# ADDENDUM NO. 1

**October 18, 2022**

## **Additions and Renovations Eastridge Elementary School**

### **TO: ALL BIDDERS OF RECORD**

DRAWING NUMBER  
**A602**

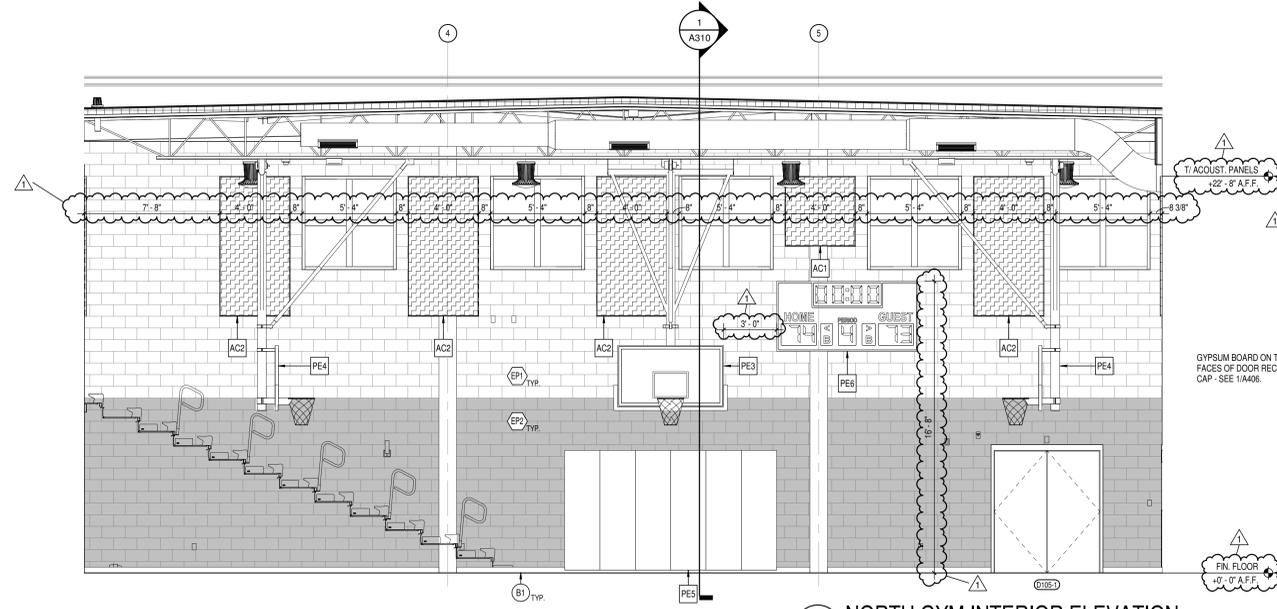
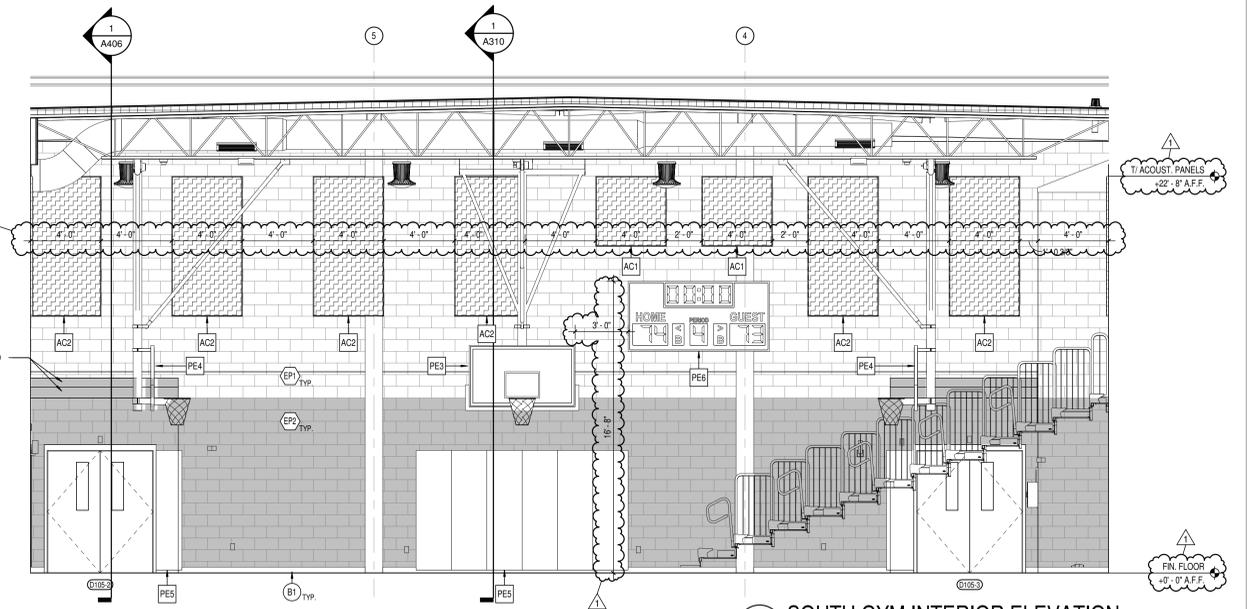
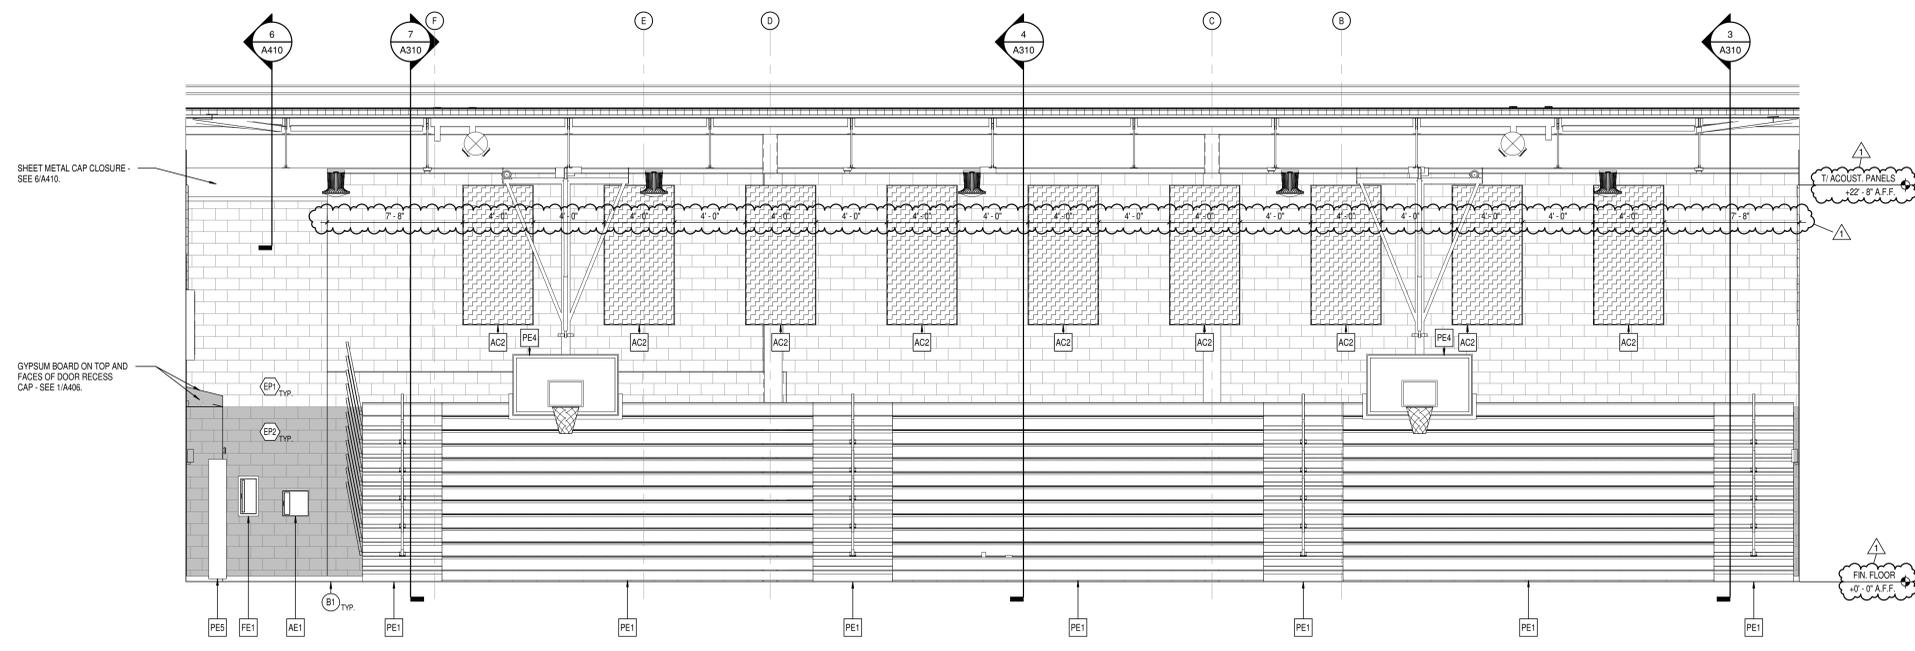
3.10 SHEET A602 – GYM INTERIOR ELEVATIONS

- A. Delete and replace entire sheet, **attached**.
- B. Added dimensions to acoustical panels and score boards.

5 ENLARGED MEDIA RECEPTION DESK  
A603 SCALE: 1/4" = 1'-0"

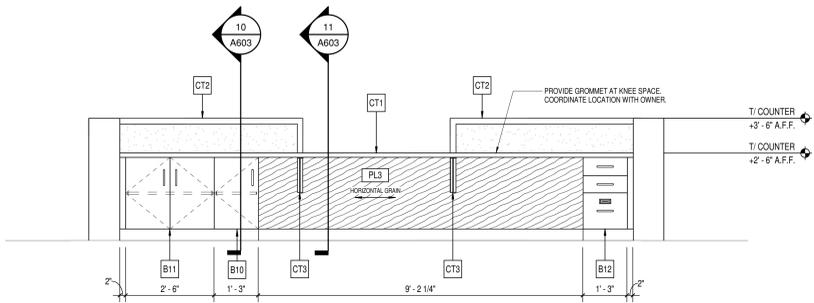
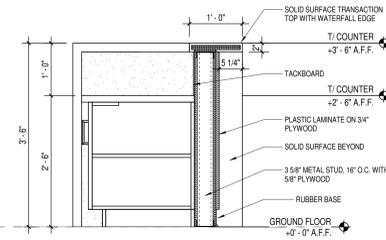
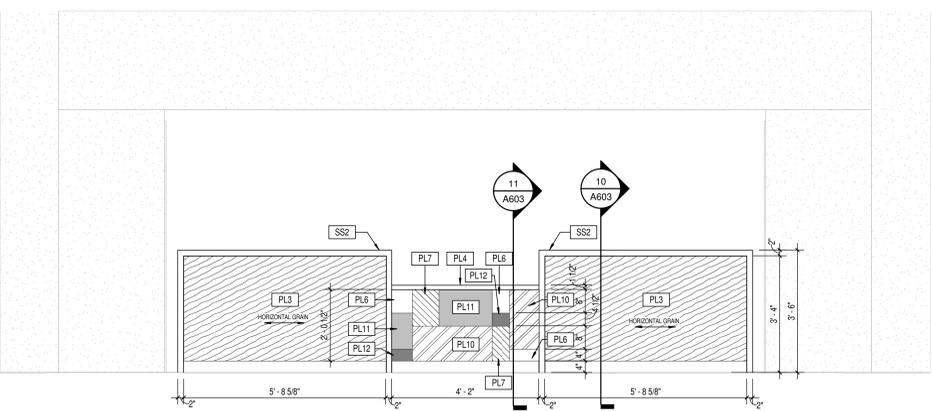
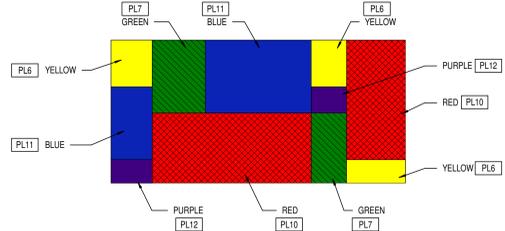
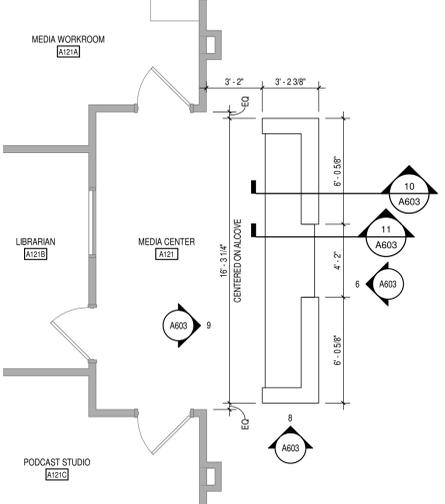
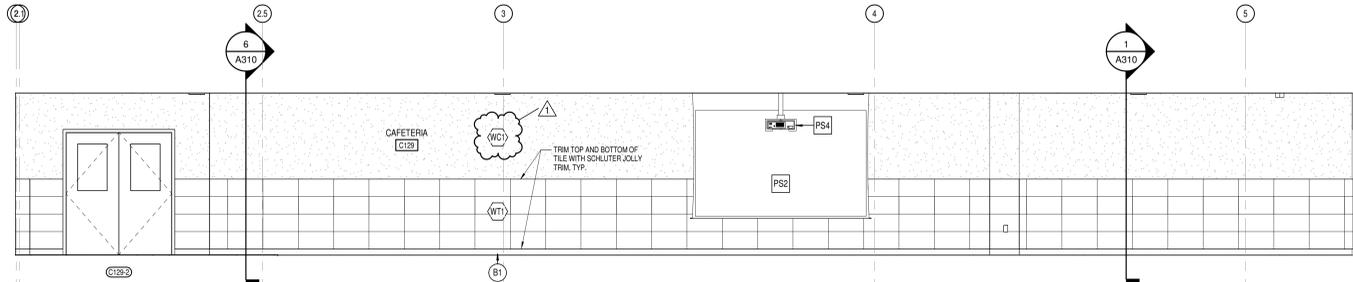
3.11 SHEET A603 – CAFETERIA AND MEDIA CENTER INTERIOR ELEVATIONS AND DETAILS

- A. Delete and replace entire sheet, **attached**.
- B. Added details and elevations for new reception desk in MEDIA CENTER A121.
- C. Revise wall finish tag in elevation 4/A604 CAFETERIA NORTH ELEVATION from ~~EP4~~ to **WC1**.

**1 ENLARGED RESTROOM PLAN**  
A701 SCALE: 1/4" = 1'-0"

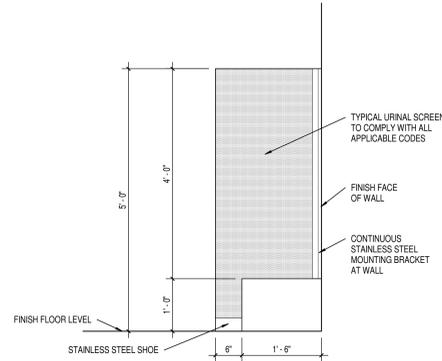
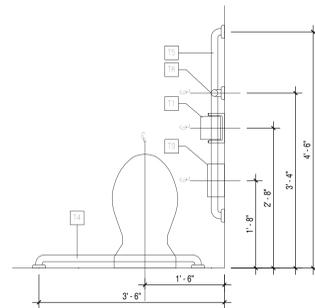
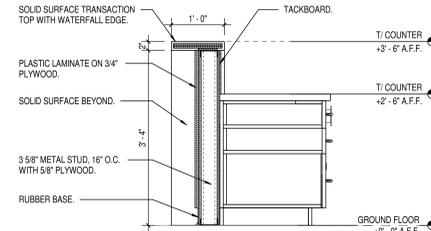
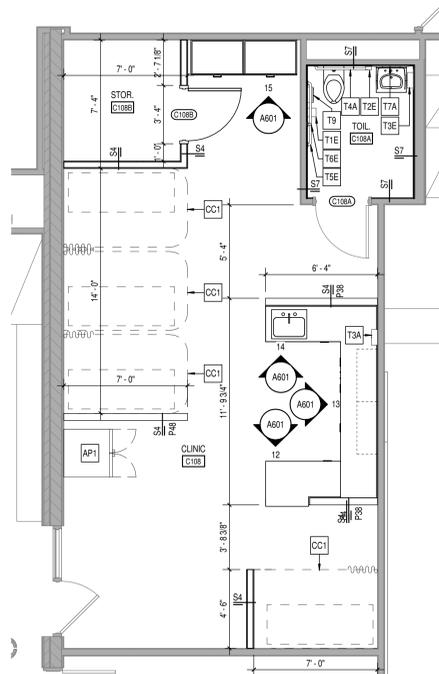
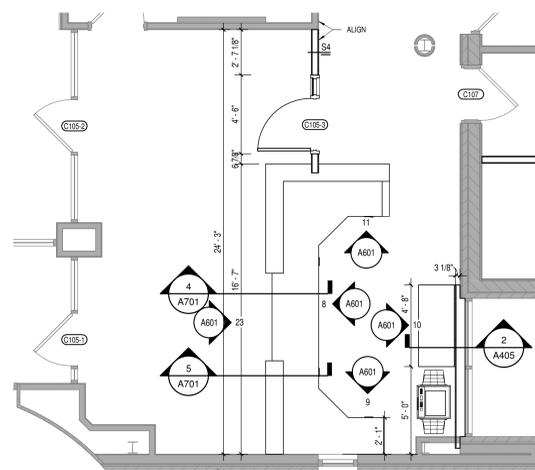
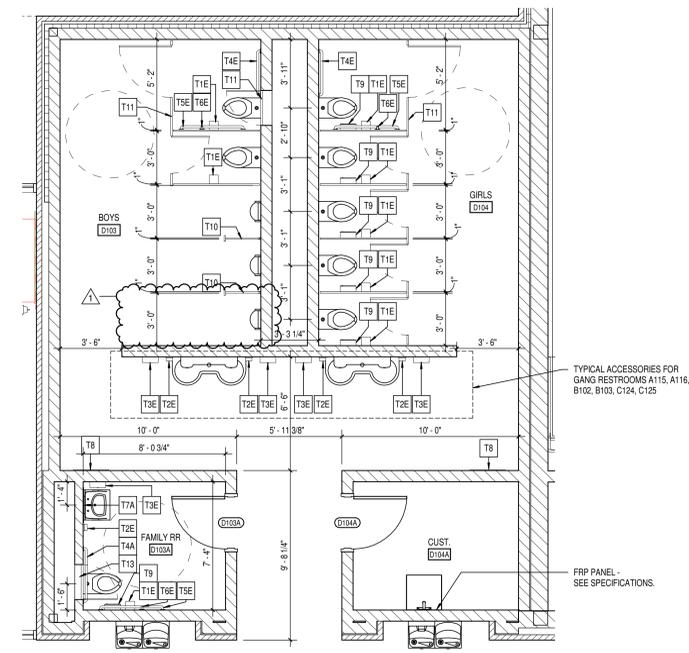
3.12 SHEET A701 – ENLARGED PLANS & TOILET ACCESSORY SCHEDULE

- A. Delete and replace entire sheet.
- B. Delete door D103 and add urinal in its location.

DRAWING TITLE:  
FINISH LEGEND  
AND  
INFORMATION

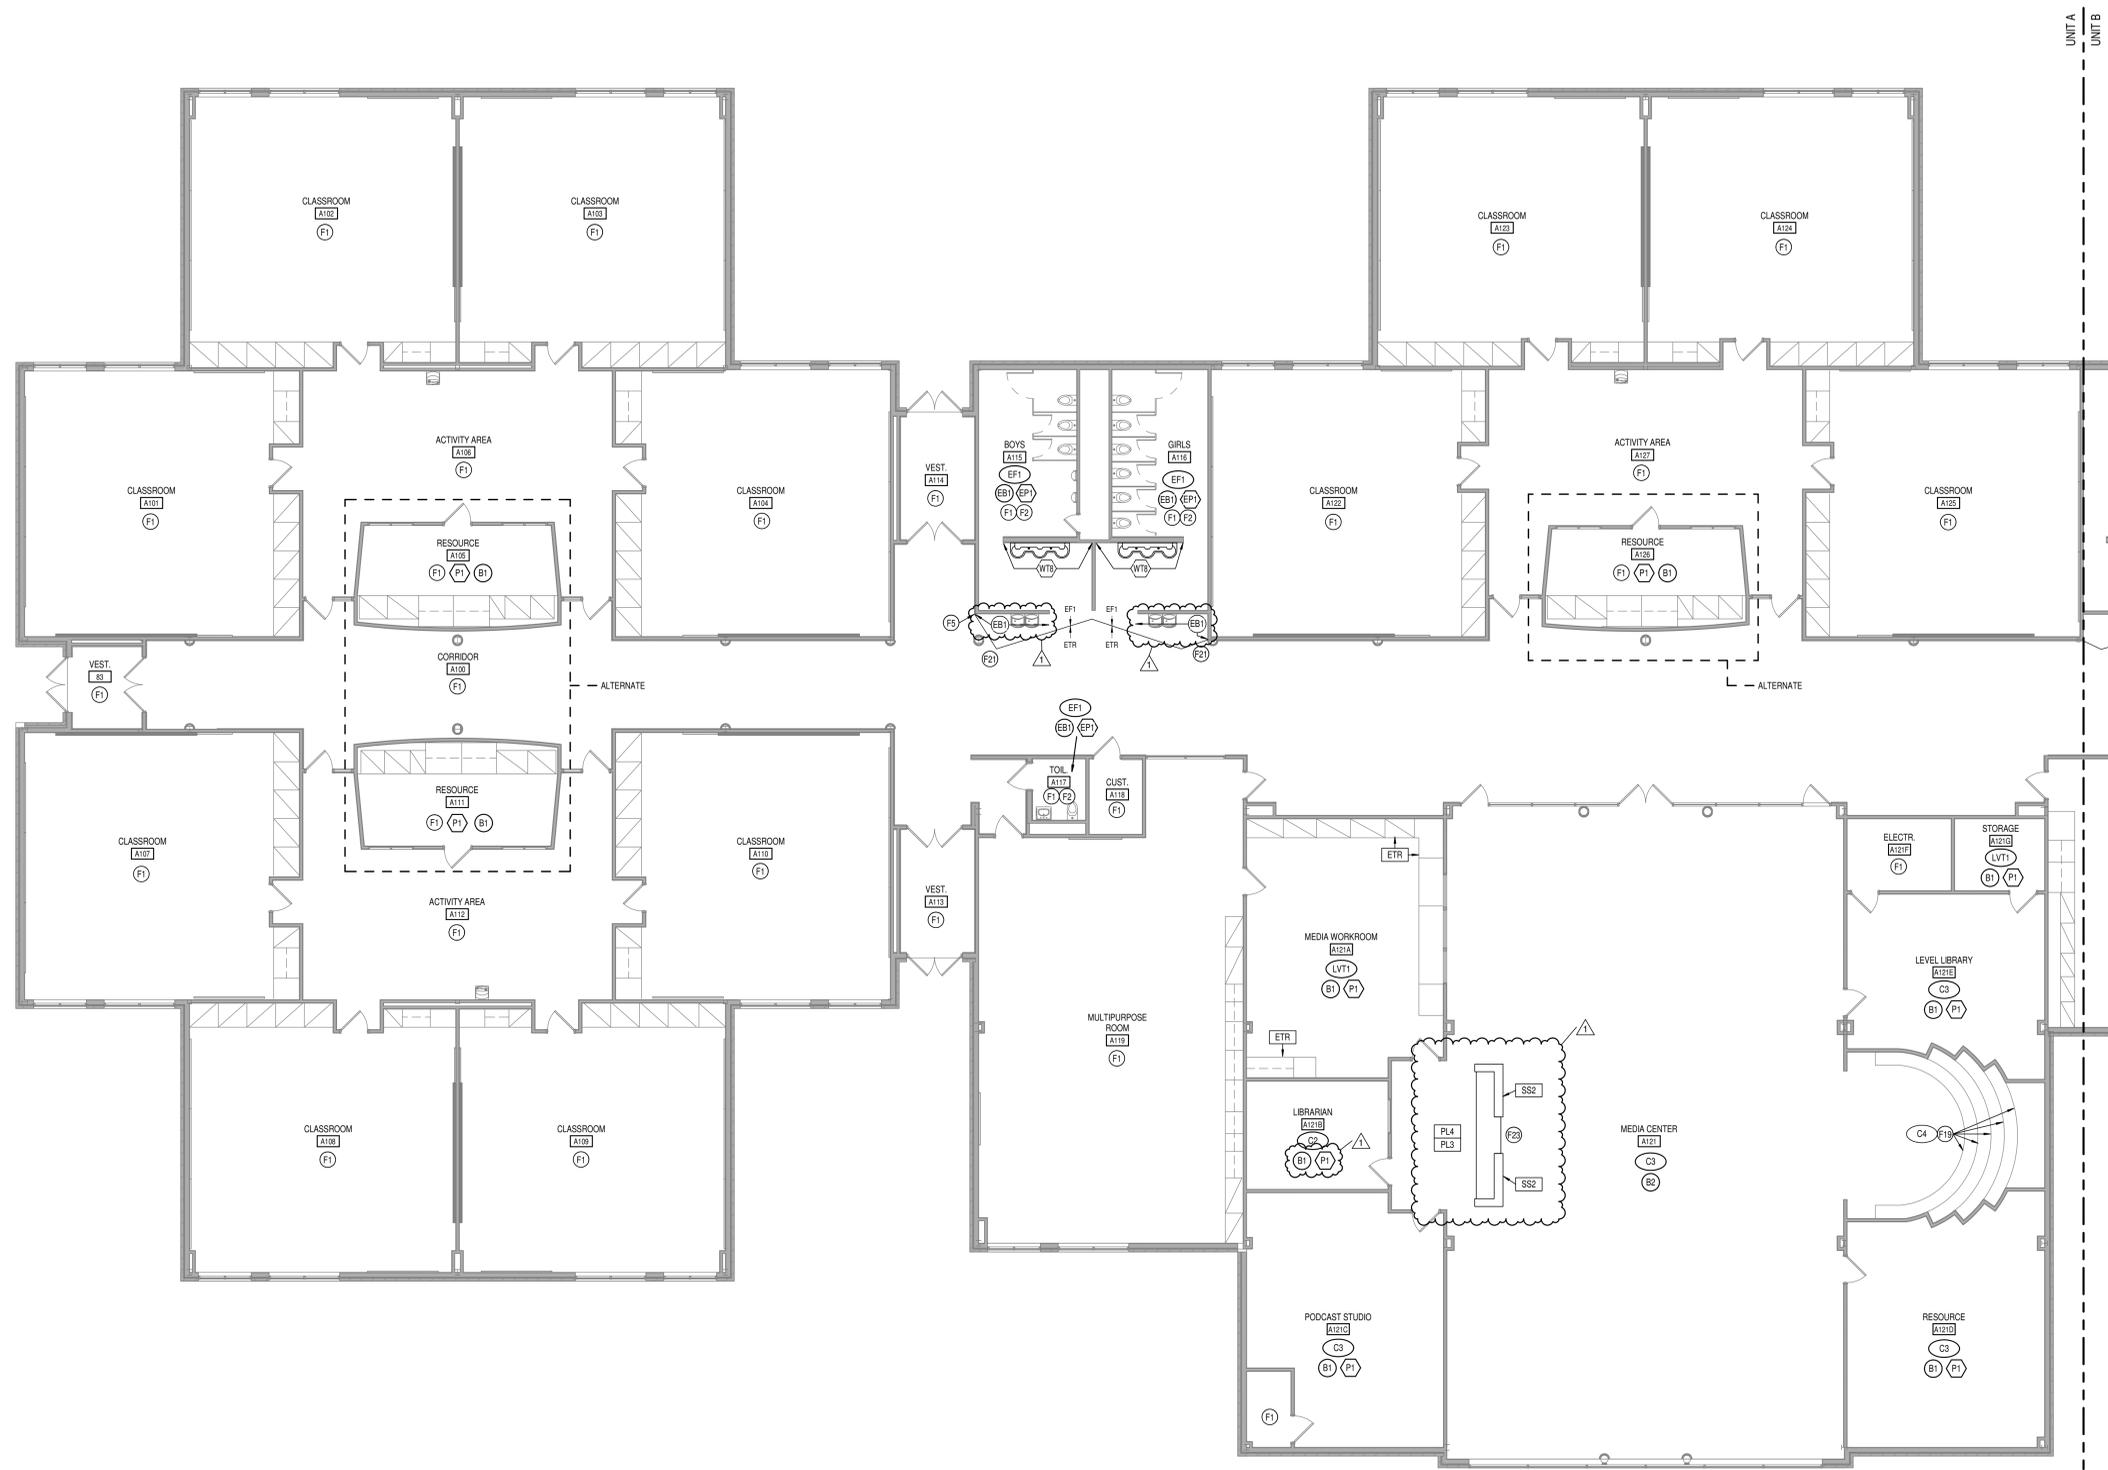
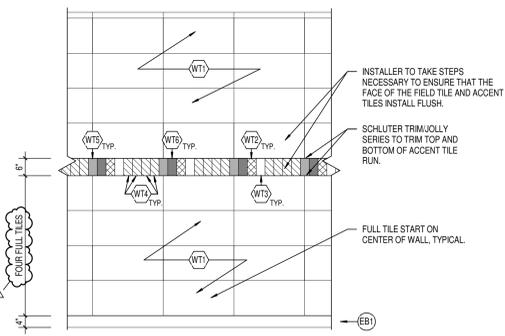
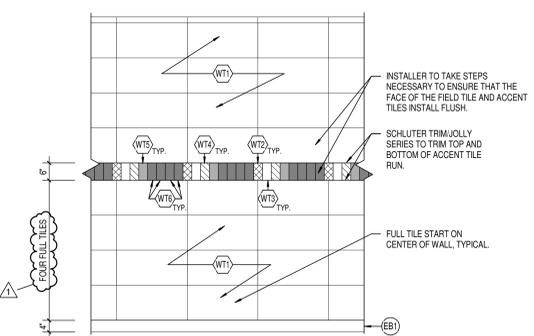
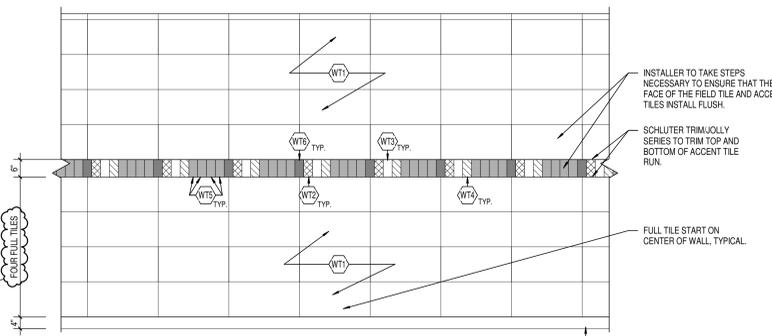
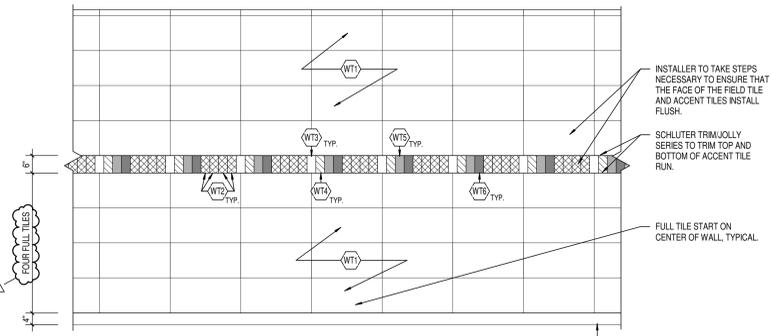
3.13 SHEET A800 – FINISH LEGEND AND INFORMATION

- A. Delete and replace entire sheet.
- B. Revised GENERAL FINISH NOTES, KEYED FINISH NOTES, FINISH LEGEND.
- C. Revised dimensions to elevations 1/A800 – 4/A800.
